Urban Planning and Land Use

To: City Planning Commission
From: City Staff
Date: April 9, 2018
Re: Petition #PR-2018-15

Requested Action:
Approval of Final Development Plan

Purpose:
To build a 210,754 square foot
Menards home improvement store

C-301
OF 23 SHEETS

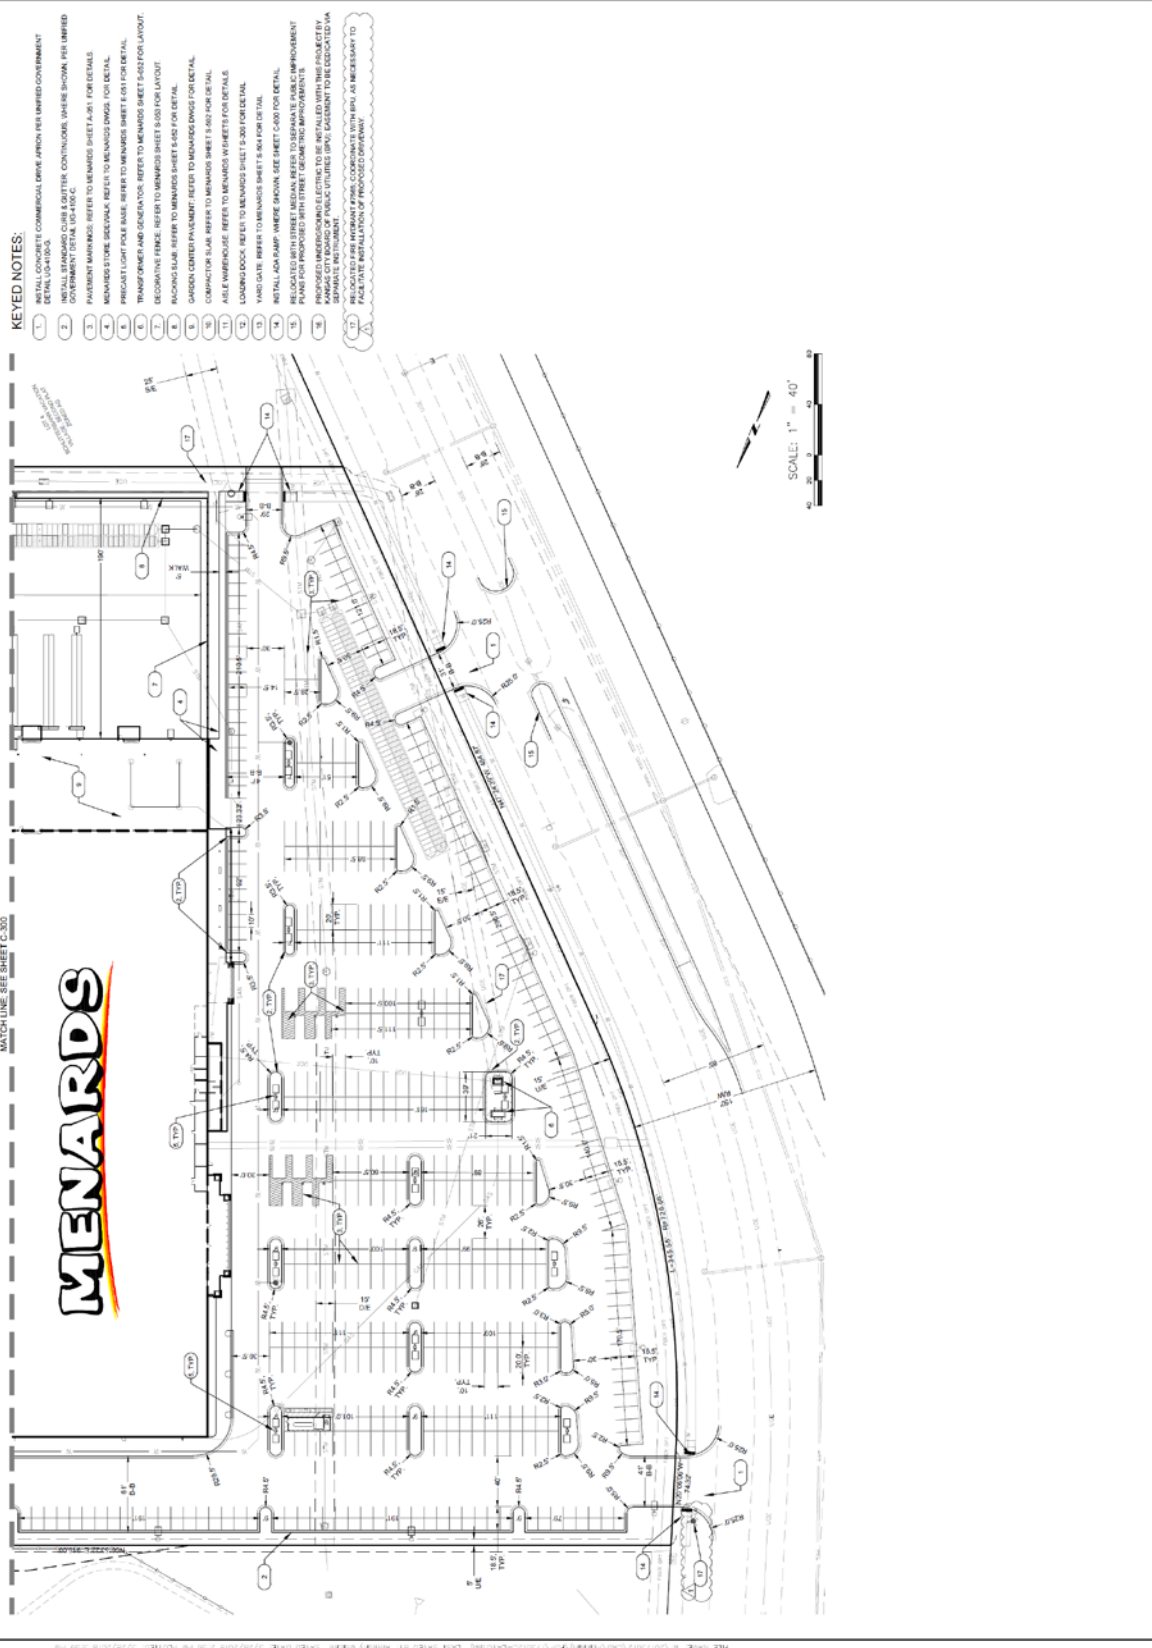
- 1) Extend the throat length of the south entrance to the drive lane adjacent to the building (See sketch)
- 2) Design driveway to accommodate the construction of a traffic signal upon meeting criteria for traffic volumes or safety warrants
